### Description

The procedure described in this document typically improves DTMF (Touch-Tone) detection in the RFC-1/B. It applies to systems that work normally when accessed from the "local phone" that is connected directly to the system but work intermittently or fail when dialing in from a remote location.

### Modification Part I

*Location of R23*

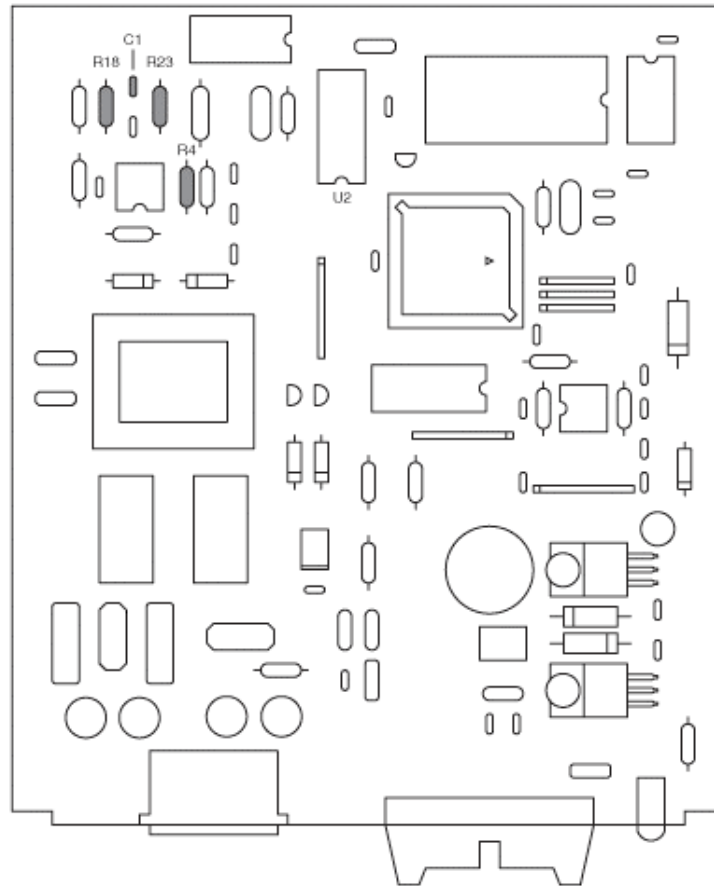
Resistor R23 should be located near the upper left corner of the RFC-1 circuit board. It is shaded in the image below. If R23 is not in the same location as shown in this image then this modification is not appropriate for your system.

The modification is a resistor substitution that involves only R23. Most RFC-1/B systems have a 270K ohm resistor at position R23. Replace this resistor with a 100K ohm, 5-10% tolerance, 1/4 watt resistor.

If the modification fails to solve the problem then substitute a smaller value resistor, about 47K ohms. If that does not work, try 10K ohms.

This modification involves R18 in addition to R23. R18 is located to the left of R23 across the two small capacitors. As before, if the location of the parts does not match the drawings then do not continue with this procedure.

Remove both R23 and R18 from the circuit. Do not replace R18 with anything and do not short it. Replace R23 with a low value resistor anywhere from 1K down to 100 ohms. If a suitable resistor is not available R23 can be shorted.

If you are in the field and do not have a low value resistor available, use the resistor removed from R18. At 33K ohms the value is a little high but with R18 removed from the circuit the value of R23 is less critical.

If the system works from the local phone but does not work when dialed in, there is another modification. Locate a very small capacitor C1 between R23 and R18 in the drawing above. If it exists in the same location on your board, carefully remove it from the circuit.

*Location of R4*

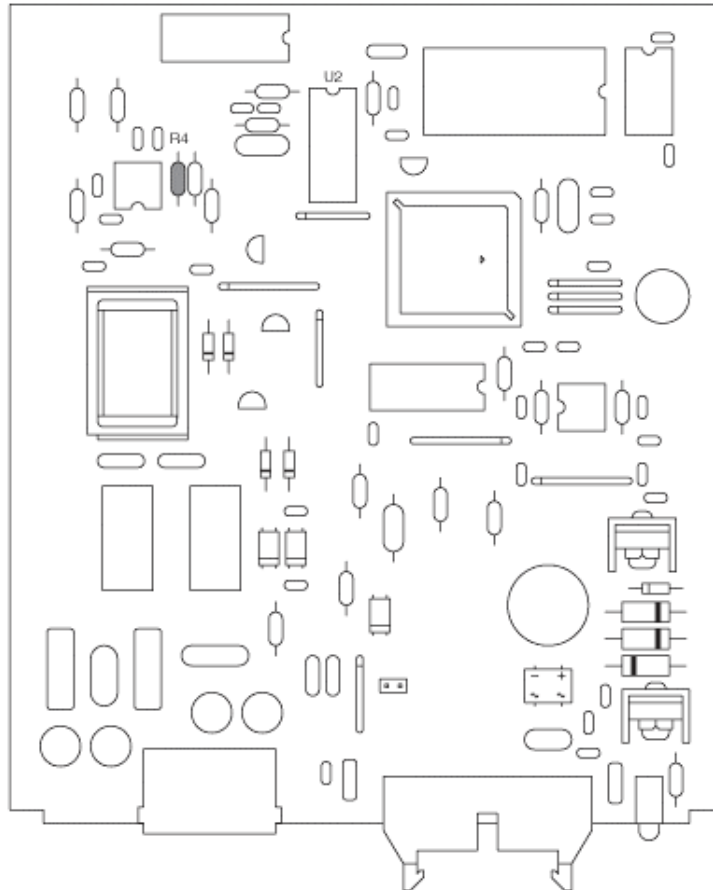
Resistor R4 should be located near the upper left corner of the RFC-1 circuit board. It is shaded in the image below. Resistor R4 should be next to the 8-pin IC in all cases. If it is not, do not make any changes.

The modification is a resistor substitution that involves only R4. Most RFC-1/B systems have a 20K ohm 1% tolerance resistor at position R4. Replace this resistor with a 27K ohm, 1% tolerance, 1/4 watt resistor.

If the modification fails to solve the problem then substitute a slightly larger value resistor, 33K ohms. If that does not work, try 39K ohms.

It is important to be conservative when changing the value of resistor R4. This procedure should solve tone detection problems on remote calls but also may potentially cause tone detection problems on the local phone if adjusted too much.
